METROPOLITAN GOVERNMENT OF NASHVILLE AND DAVIDSON COUNTY

STAFF RECOMMENDATION
1616 Douglas Avenue
February 15, 2017

Application: New construction – infill
District: Eastwood Neighborhood Conservation Zoning Overlay
Council District: 06
Map and Parcel Number: 08302018400
Applicant: Kyle Boswell
Project Lead: Melissa Sajid, melissa.sajid@nashville.gov

Description of Project: The applicant proposes to construct a new single-family home.

Context Photos

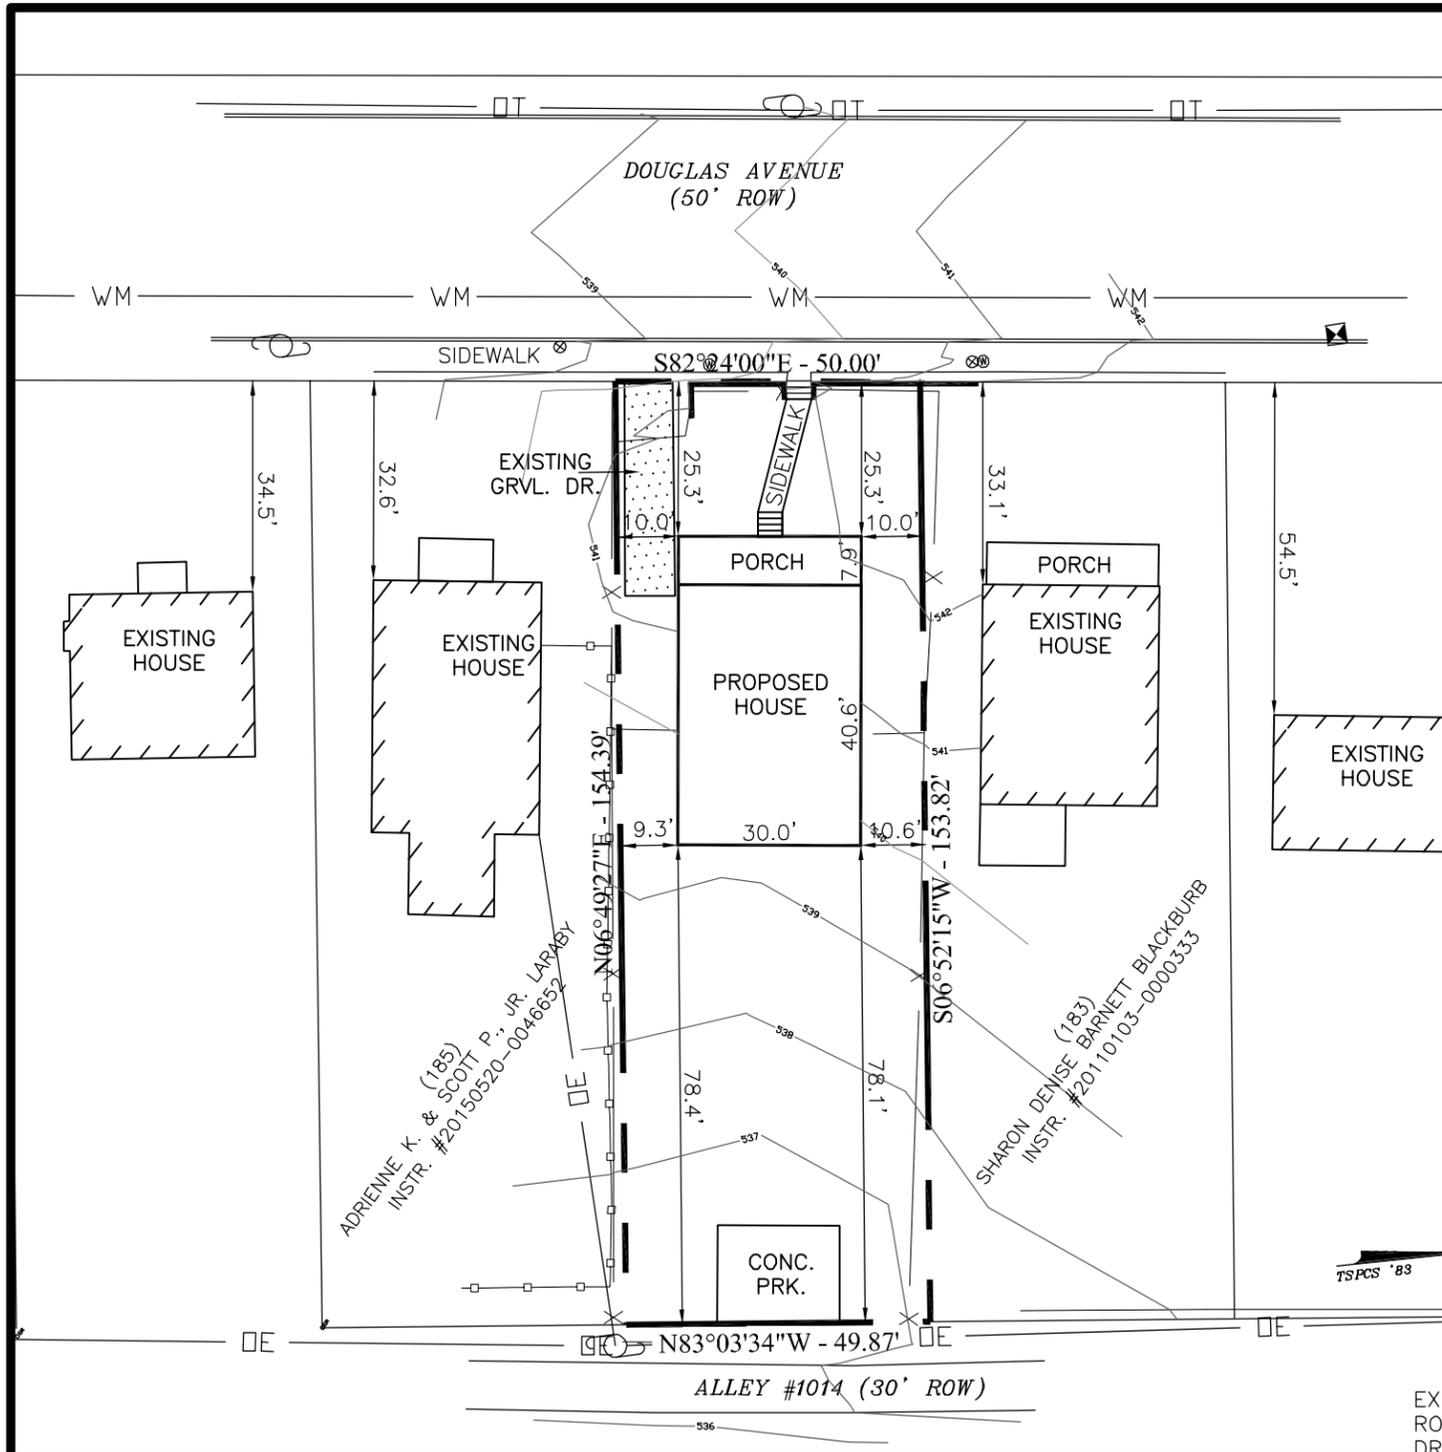
Height & Scale: The proposed infill is one and one-half (1.5) stories at the front with an overall height of twenty-three feet, six inches (23'-6") from grade. The proposed overall height is slightly taller than historic homes in the immediate vicinity, which includes one and one-half story (1-1.5) story homes that range from twenty to twenty-three feet (20'-23') from grade. However, staff finds the overall height to be appropriate since the infill will be only six inches (6") taller than the historic house next door at 1614 Douglas Avenue, and the additional six inches (6") of height is unlikely to be perceived from the street. The infill will have an eave height of approximately nine feet, eight inches (9'-8"), which is appropriate for a one and one-half (1.5) story home.

Setback & Rhythm of Spacing: The proposed infill meets all base zoning setbacks. The side setbacks will be approximately nine feet, four inches (9'-4") on the right and ten feet, seven inches (10'-7") on the left, which maintains the rhythm of spacing on the street. At twenty-five feet, four inches (25'-4"), the front setback will be an average of the front setbacks of the historic houses on either side of the site. Staff finds that the infill's setbacks and rhythm of spacing meet section II.B.c of the design guidelines.

SITE PLAN
1616 DOUGLAS AVENUE

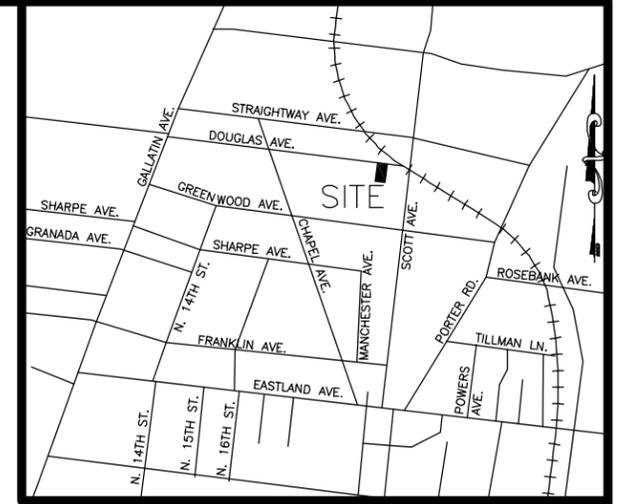
Appurtenances & Utilities: The infill includes a walkway leading from the street to the front porch as well as a concrete parking pad located off the alley. An existing curb cut from Douglas Avenue with a gravel drive currently serves the site and will remain. The location of the HVAC and other utilities was not noted on the plans. Staff asks that the HVAC would be located on the rear façade, or on a side façade beyond the midpoint of the house, to ensure that the project meets section II.B.i of the design guidelines.

ROOF PLAN
1.20.11
SCALE 1/8" = 1'-0"
REVISION NO. 0

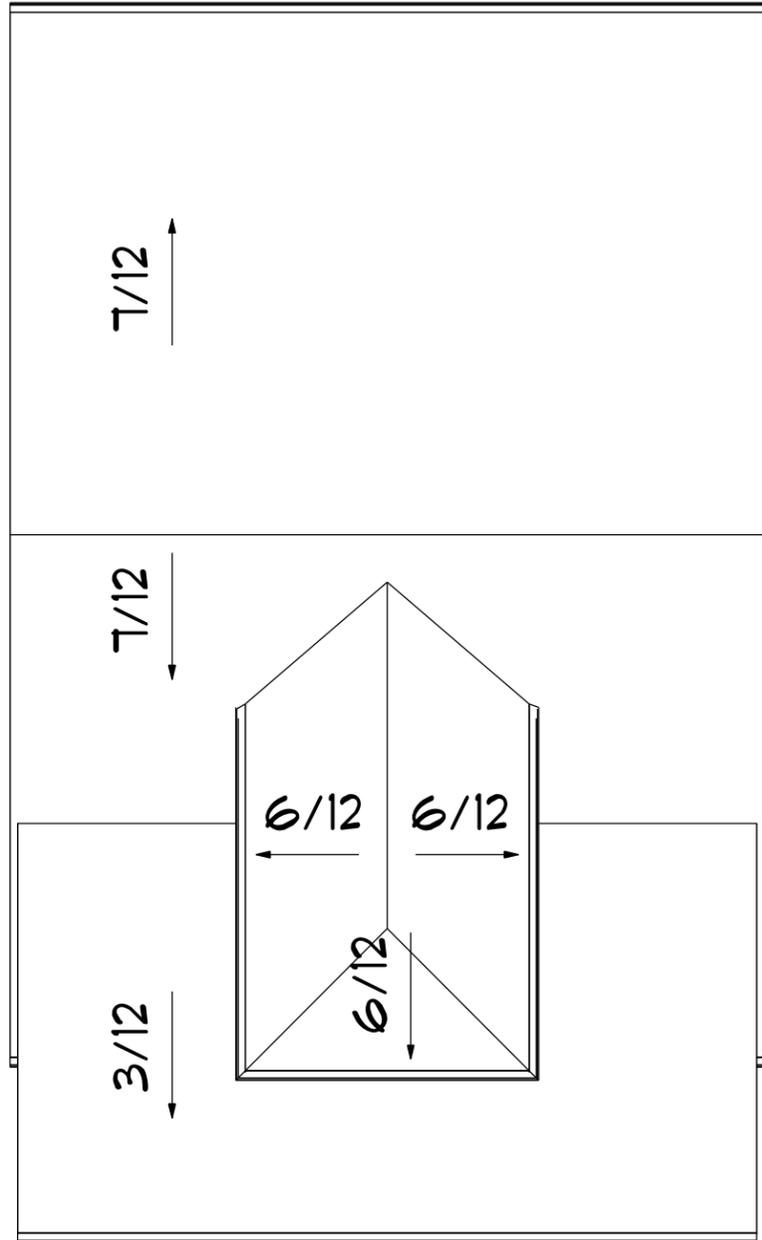
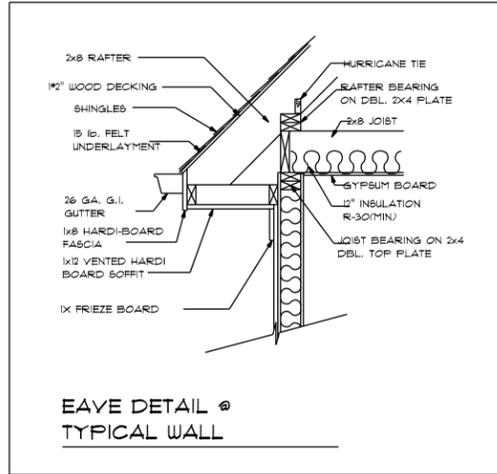
Roof form: The roof will be side-gabled with a 7:12 pitch and includes a clipped front-gabled dormer on the front façade that will be set in two feet (2') from the wall below. Staff finds that the roof form and pitches are compatible with the historic context and meet section II.B.e of the design guidelines.
